## Some thoughts on "The Pointe" and the sewer capacity

In Monday 3/21's ZBA meeting where sewer concerns were being addressed by the proponent of the 40B project called "the Pointe", I found the assertions about using a 95% maximum capacity to be concerning. The amount of flow through a pipe is proportional to its cross section, and it goes down exponentially with a reduction in the radius. This means that to decrease the capacity of a 10" pipe requires a very small reduction in radius. Any buildup inside of a sewer pipe reduces its radius and therefore exponentially its capacity. This may explain why the peer review firm uses an 80% guideline instead of 95%.

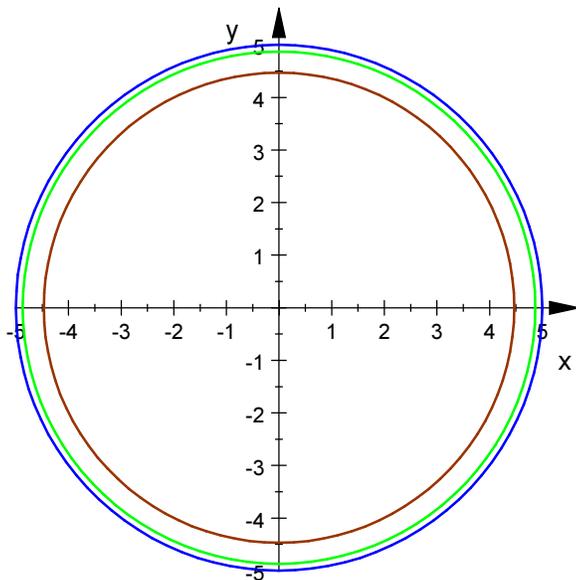
The proponent's margin where we can run the pipes at 95% capacity gives a margin signified by the the area between the green and blue circles. The peer review's margin where we can run the pipes at 80% capacity is signified by the area between the brown and blue circles. The proponent's own projections start many of the pipes at 94% capacity (worst case, which is what you must plan for) but they somehow conclude that this is enough.
